City of El Paso – City Plan Commission Staff Report

Case No:	SUSU13-00050 Mesquite Trails Unit Seven
Application Type:	Major Final
CPC Hearing Date:	July 11, 2013
Staff Planner:	Nelson Ortiz, (915) 541-4931, ortiznx@elpasotexas.gov
Location:	North of Pellicano and East of Sunfire
Acreage:	22.84 acres
Rep District:	6
Existing Use:	Vacant
Existing Zoning:	R-3A
Proposed Zoning:	R-3A
Nearest Park:	Paseo Del Sol Park (.47 mile)
Nearest School:	John Drugan Elementary School (0.18 mile)
Park Fees Required:	N/A
Impact Fee Area:	N/A
Property Owner:	Americas Loop 375 Joint Venture
Applicant:	Tropicana Development
Representative:	CEA Group

ATTACHMENT 3

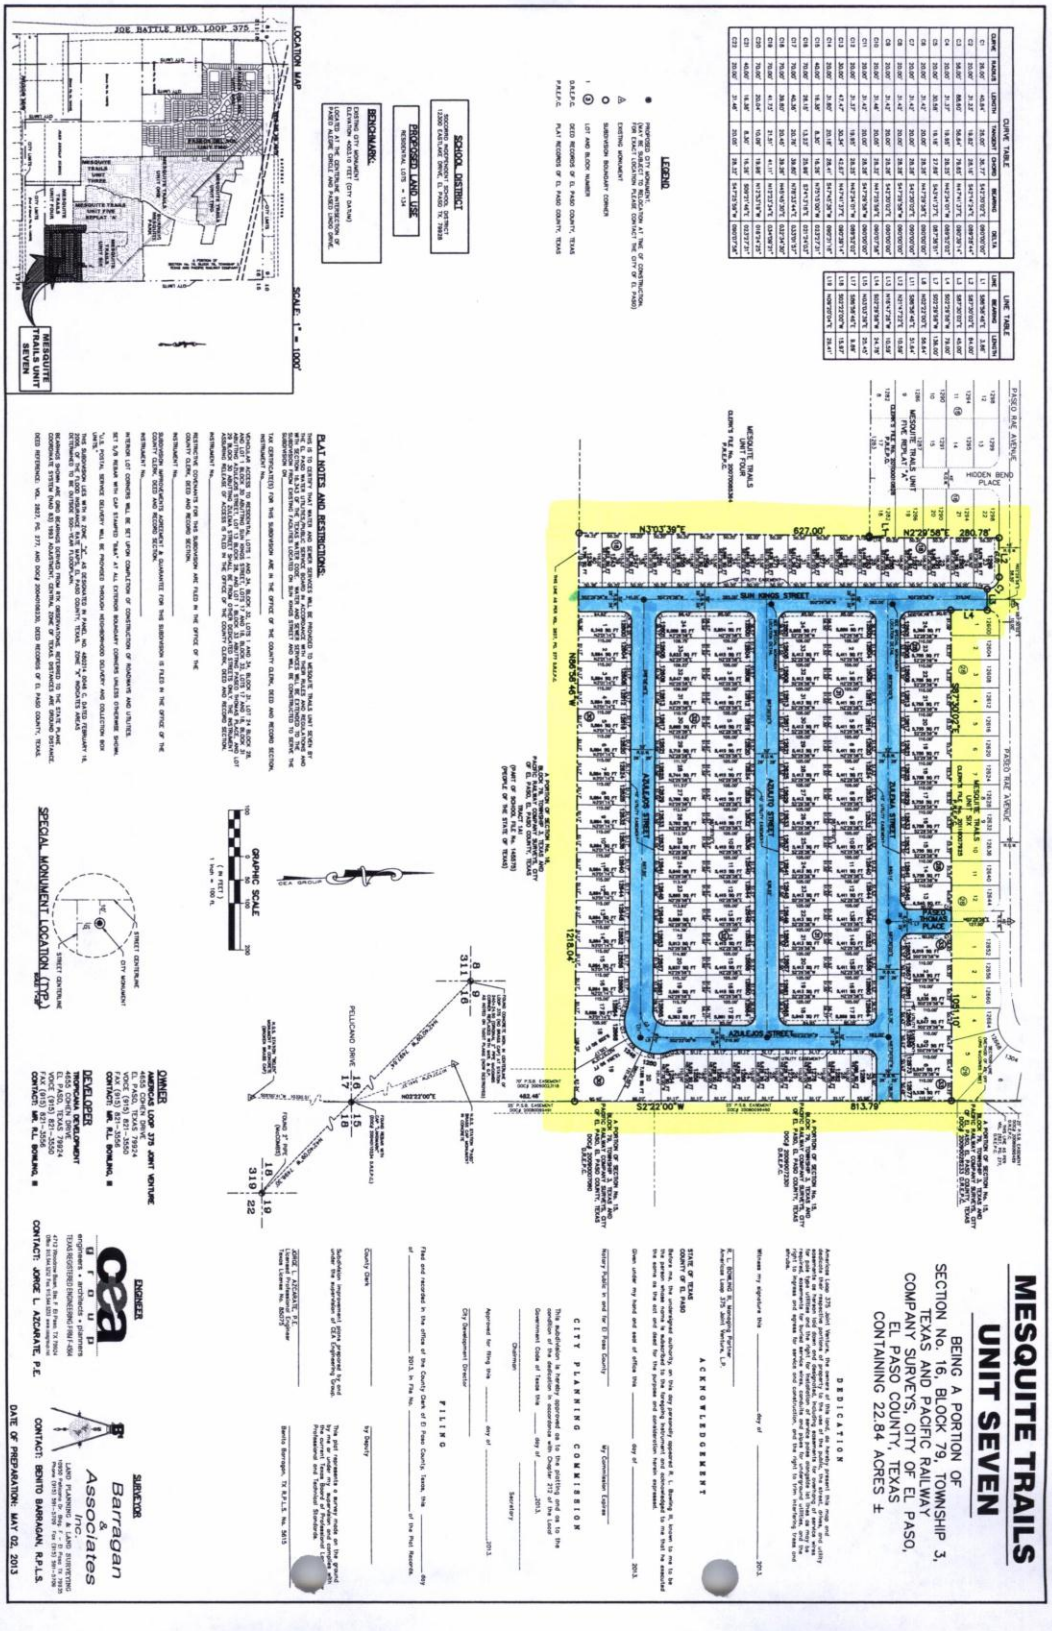
- Requests that **AZULEJOS STREET be divided into two separate streets with two separate street names** because of an address numbering conflict. Efficiency with emergency response is potentially at risk when a single street name has four (4) digit address numbers neighbor with five (5) digit address numbers.

Central Appraisal District
- Please change Block 30 to Block 42
